Access Compliance Report

Public Rights-of-Way

Intersection ID: 10033675	Main Street: ORCHARD_LAKE_DR	Cross Street: N/A	Location: S
ADA ID: F2F15ED67B37	Ramp Type: BlendTrans1	Initial Pass/Fail: Fail	Overall Compliance: No
Severity Score: 1.25			
Codes/Mitigation Info/Possible Solution		Field Measurements/Component Compliance

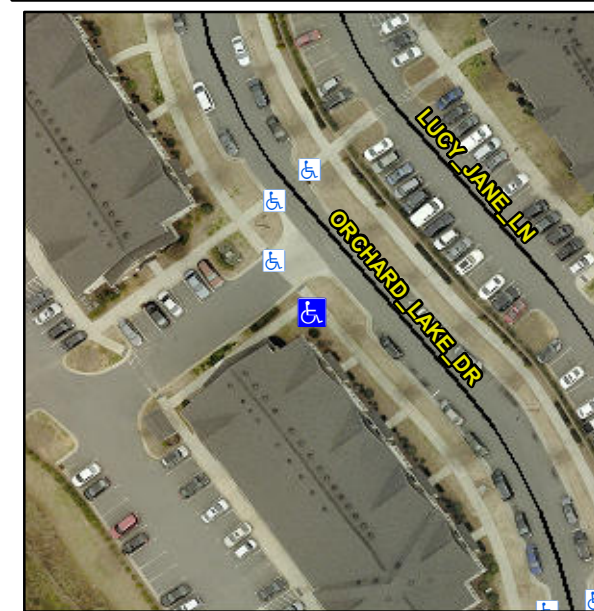
Not Found, R304.5.3

Compliance	Description	Data	Compliance	Description	Data
N/A	Ramp Length (in)	72.0	Yes	BlendTrans Slope (%)	4.2
Yes	Ramp Width (in)	73.0	No	BlendTrans XSlope (%)	3.8
N/A	Flare Type LT	N/A	N/A	Flare Type RT	N/A
N/A	Flare Slope LT (%)	N/A	N/A	Flare Slope RT (%)	N/A
N/A	Flare Traversable LT?	N/A	N/A	Flare Traversable RT?	N/A
N/A	Landing Length (in)	N/A	N/A	DWS Provided?	N/A
N/A	Landing Width (in)	N/A	N/A	DWS Contrast?	N/A
N/A	Landing Slope (%)	N/A	N/A	DWS Length (in)	N/A
N/A	Landing X Slope (%)	N/A	N/A	DWS Full Width?	N/A
N/A	Landing Curb? (Y/N)	N/A	N/A	DWS Offset (in)	N/A
N/A	Shared Landing?	N/A			
N/A	Gutter Ponding?	N/A	N/A	Gutter Slope (%)	N/A
N/A	Gutter Lip Ht (in)	N/A	N/A	Gutter X Slope (%)	N/A
N/A	Painted X Walk1?	No	N/A	Painted X Walk2?	N/A
	X Walk 1 Direction	To NW		X Walk 2 Direction	N/A
	X Walk 1 Width (in)	N/A		X Walk 2 Width (in)	N/A
	X Walk 1 Slope (%)	1.2		X Walk 2 Slope (%)	N/A
	X Walk 1 X Slope (%)	1.8		X Walk 2 X Slope (%)	N/A

N/A	Ramp inside XWalk1?	N/A	N/A	Ramp inside XWalk2?	N/A
	Road Slope (%)	1.8		Clear Space?	N/A
	Road X Slope (%)	1.2	N/A	Clear Space to XWalk (in)	N/A
N/A	Any Obstructions?	N/A	N/A	Storm Grate/Utility Hazard?	N/A
	Obstruction Type			Storm Grate/Utility Type	
		N/A			N/A
			Yes	Surface Condition? (G/P)	Good
			No	Curb Slope (%)	5.4

Remove & Replace Curb Ramp With Two New Directional Ramps or Equivalent.
